Item Name: Fwd Crosstube - Extended Height 31"

DART AEROSPACE LTD		Work Order: 142119
Description: Crosstube High-High Fwd		Part Number: D205-596-105
Inspection Dwg: D205-596-105 Rev: B		Page 1 of 1

DRAWING NO. D205-596-105	TITLE CROSSTUBE ASS'Y, HI-HI FWD	REV. B	DART AEROSPACE LTD ENGINEERING ORDER		D.E.O. NO. D205-596-105-B-2	SHEET NO. SHEET 1 OF 1	SCALE NTS
DRAWN <i>MP</i>	CHECKED A.P.	MFG. APPR. <i>MP</i>	APPROVED <i>MP</i>	DE APPR. <i>MP</i>			
DATE 13.11.11	DATE 13.11.19	DATE 13.11.19	DATE 13/11/21	DATE 13/11/21

DRAWING NO. D205-596-105	TITLE CROSSTUBE	REV. B	DART AEROSPACE LTD ENGINEERING ORDER		D.E.O. NO. D205-596-105-B-3	SHEET NO. SHEET 1 OF 1	SCALE NTS
DRAWN <i>JP</i>	CHECKED <i>A.P.</i>	MFG. APPR. <i>JA</i>	APPROVED <i>AB</i>	DE APPR. <i>H</i>			
DATE 15.01.15	DATE 15.01.20	DATE 15.01.20	DATE 15.01.20	DATE 15.01.20

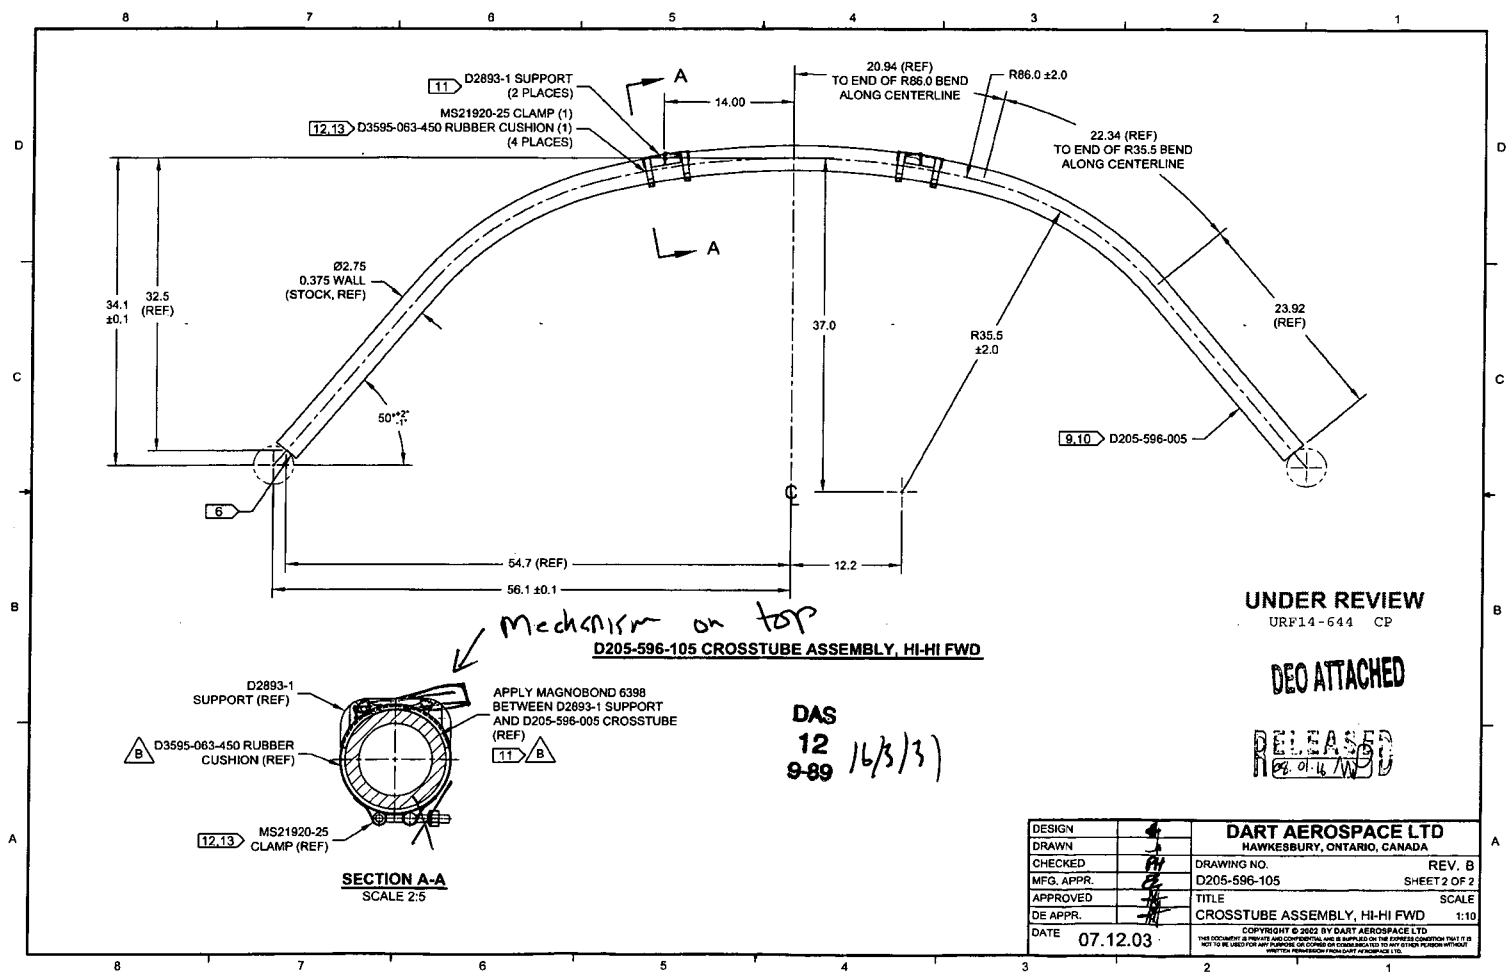
PURPOSE:
REPLACE MAGNOBOND WITH PROSEAL.

CHANGE:

IS:

Qty	Part Number	Description
A/R	PROSEAL 890 B-2	SEALANT, AMS-S-8802 CLASS B-2

WAS:

A/R	MAGNOBOND 6398	ROCKWELL SPECIFICATION RBO-120-023 ADHESIVE (TEXTRON/BELL SPEC. 299-947-100, TYPE II, CLASS 2 ADHESIVE)
-----	----------------	---

NOTE 11 & 13, SHEET 1 IS AMENDED AS FOLLOWS:

IS:

- 11) TO INSTALL D2893-1 SUPPORT: ABRASE MATING SURFACE OF SUPPORT AND CROSSTUBE WITH 180-GRIT SANDPAPER AND REMOVE RESIDUE WITH MEK (OR EQUIVALENT). APPLY A 0.04" TO 0.07" THICK LAYER OF PROSEAL 890 CLASS B-2 (OR AMS-S-8802 CLASS B-2) SEALANT TO MATING SURFACE OF SUPPORT.
- 13) TORQUE CLAMPS 80 TO 100 IN-LB. ENSURE AT LEAST 1.5 THREADS SHOWING IN SAFETY AND THAT NUT HAS NOT BOTTOMED-OUT AFTER TORQUING. PRIOR TO PACKAGING, RE-CHECK TORQUE ON CLAMPS AFTER PROSEAL 890 SEALANT HAS CURED FOR 72 HOURS.

WAS:

- 11) APPLY A 0.03" TO 0.06" THICK LAYER OF MAGNOBOND 6398 TO THE SURFACE OF D2893-1 THAT WILL BE IN CONTACT WITH THE CROSSTUBE. LET CURE FOR 12 HOURS AFTER INSTALLATION AND PRIOR TO PACKAGING.
- 13) TORQUE CLAMPS 80 TO 100 IN-LB.

FIGURE 1 - SUPPORT INSTALLATION

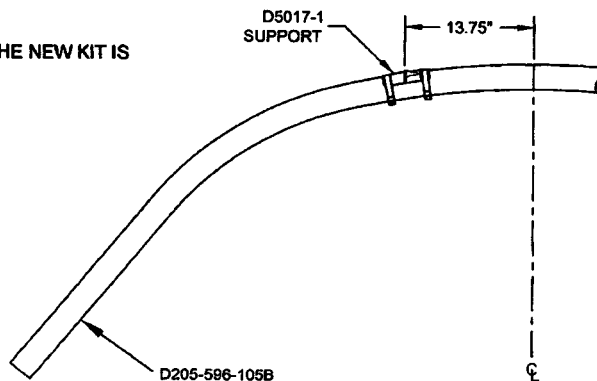
ADD THE FOLLOWING CROSSTUBE ASSEMBLY:

Qty	Part Number	Description
X	D205-596-105B	CROSSTUBE ASSEMBLY (214 HI-HI FWD)

THE D205-596-105B CROSSTUBE HAS THE SAME PARTS LIST AS THE D205-596-105 CROSSTUBE EXCEPT AS FOLLOWS:

IS:

2	D5017-1	SUPPORT
---	---------	---------

WAS:

2	D2893-1	SUPPORT
---	---------	---------

INSTALL THE SUPPORTS AS SHOWN IN FIGURE 1 OF THIS ENGINEERING ORDER. THE NEW KIT IS OTHERWISE ASSEMBLED PER THE D205-596-105 CROSSTUBE.
